Technical Bulletin

Starter shaft support for starter SJCE 0,9 kW

L 2000 EA

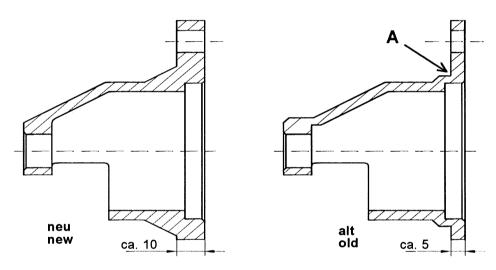
Broken starter shaft support on engines, which are equipped with the abovementioned starter in several cases, as indicated by arrow "A".

3. Replace old style starter shaft support with new unit P/No.: 202.143.201.000
